Link Management Parameters for 10 Mb/s Operation and Associated Power Delivery over a Single Balance

CI 45 SC 45.2.7.25.1 P 58 L 35 # i-230

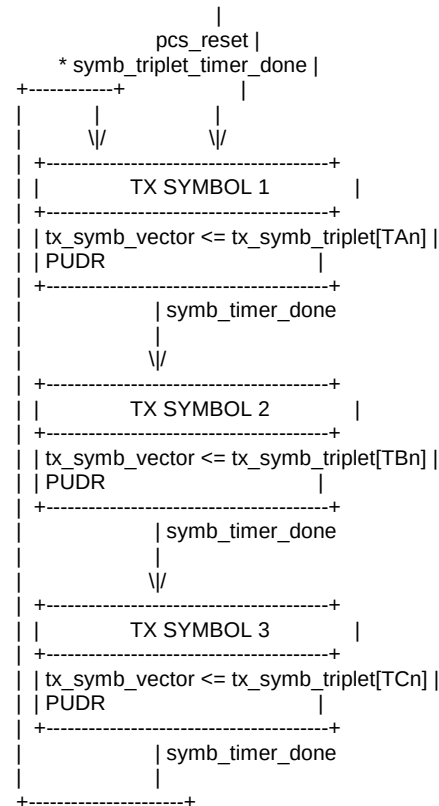
Is it correct that 'The PCS Transmit function shall conform to the PCS Transmit state diagram in Figure 146-5 ...' and that 'In each symbol period, PCS Transmit generates a symbol An provided to the PMA ...'? The PCS Transmit state diagram in Figure 146-5 changes state based on STD being true, with STD being an alias for symb_triplet_timer_done, and the output of the PCS Transmit state diagram is tx_symb_triplet which is defined in subclause 146.3.3.1.1 'Variables' as 'A triplet of ternary symbols generated by the PCS Transmit function after 4B3T encoding.'

I think the problem is that there is another function within the PCS Transmit function that is missing from the PCS Transmit state diagram in Figure 146-5, the 'multiplexor' shown in Figure 146-6 'PCS transmit symbol generation'. This 'multiplexor' function operates at the symbol clock rate and serialises the tx_symb_triplet code-groups output by the PCS Transmit state diagram into individual symbols.

This may also explain when subclause 146.3.3.1.3 'Timers' defines the symb_timer that is not used in the PCS Transmit state diagram in Figure 146-5.

[4] Add a new subclause 146.3.3.2.2 titled 'Timers'. Move the symb_timer definition from subclause 146.3.3.1.3 Timers to this new subclause.

[5] Add a new subclause 146.3.3.2.4 'Abbreviations' that reads:

[6] Insert a new Figure 145-6 shown below (view using a non-proportional font such as courier), renumbering the following figures as required.

[7] Add text to subclause 146.3.3 'PCS Transmit' that reads 'The PCS Transmit function shall conform to the PCS Transmit state diagram in in Figure 146-5 and the PCS Transmit multiplexor state diagram in 146-6, and their associated state variables, functions, timers, and messages.'
